TVA-SQN-TS-98-10

SEQUOYAH NUCLEAR PLANT (SQN) - UNITS 1 AND 2 - TECHNICAL SPECIFICATION (TS) CHANGE NO. 98-10, REVISION 2 "ENHANCEMENT OF REACTOR COOLANT LEAKAGE DETECTION AND OPERATIONAL LEAKAGE CONSISTENT WITH STANDARD TECHNICAL SPECIFICATIONS" (NUREG-1431)

**PROPOSED TECHNICAL SPECIFICATION (TS) CHANGE 98-10
FOR REVISION 2**

FIGURE 3.5.6-1
Seal Injection Flow Limits

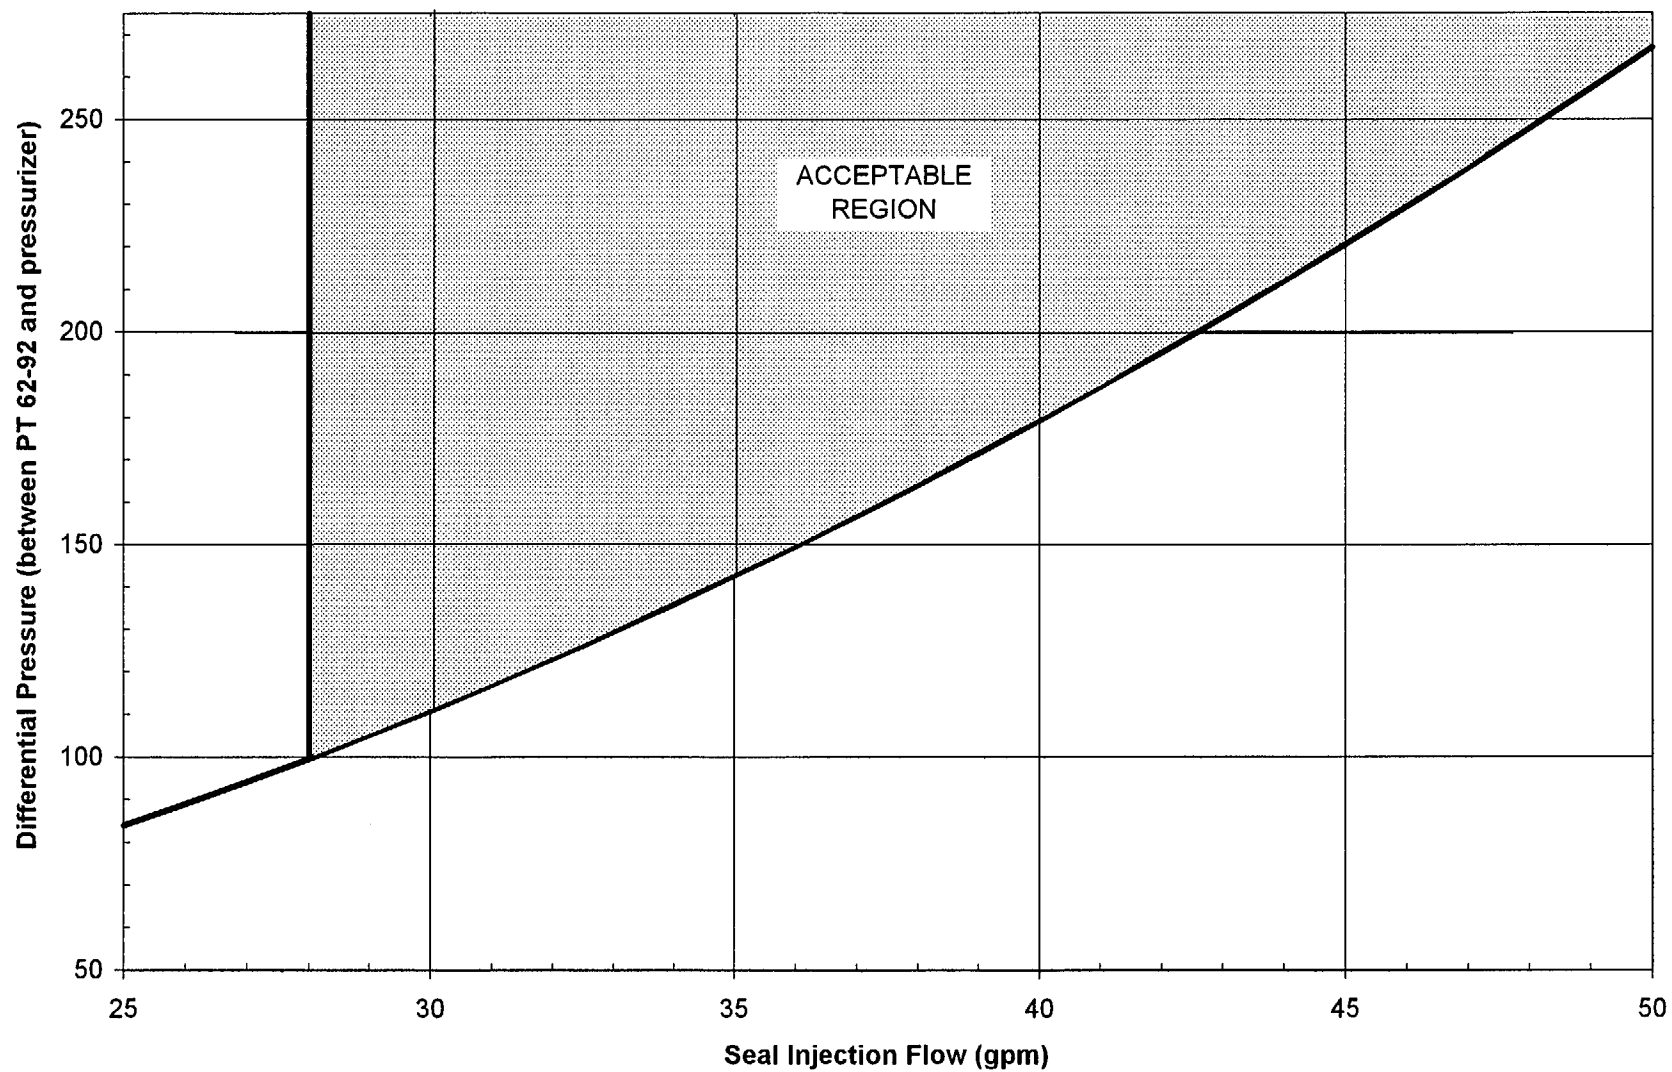
The proposed revision does not alter the intent of the original request associated with the seal injection flow requirements and is changed only by the location of the curve for these limits. The appropriate portions of Specification 3.5.6 and the associated Bases have been revised in this request to reference the new location within Specification 3.5.6. The other portions of the original submittal and Revision 1 remain unchanged and are not affected by this proposal. The enclosure contains copies of the appropriate TS pages for the seal injection flow portion of the proposed revision from Units 1 and 2 with the proposed changes incorporated.

3.5.6 Reactor coolant pump seal injection flow shall be within the limits of Figure 3.5.6-1.

4.5.6 At least once per 31 days* verify manual seal injection throttle valves are adjusted to give a flow within the emergency core cooling system safety analysis limits in Figure 3.5.6-1 .

The LCO is not strictly a flow limit, but rather a flow limit based on a flow line resistance. In order to establish the proper flow line resistance, a pressure and flow must be known. The flow line resistance is established by adjusting the RCP seal injection needle valves to provide a total seal injection flow in the acceptable region of Technical Specification Figure 3.5.6-1. The centrifugal charging pump discharge header pressure remains essentially constant through all the applicable MODES of this LCO. A reduction in RCS pressure would result in more flow being diverted to the RCP seal injection line than at normal operating pressure. The valve settings established at the prescribed centrifugal charging pump discharge header pressure result in a conservative valve position should RCS pressure decrease. The flow limits established by Technical Specification Figure 3.5.6-1 are consistent with the accident analysis.
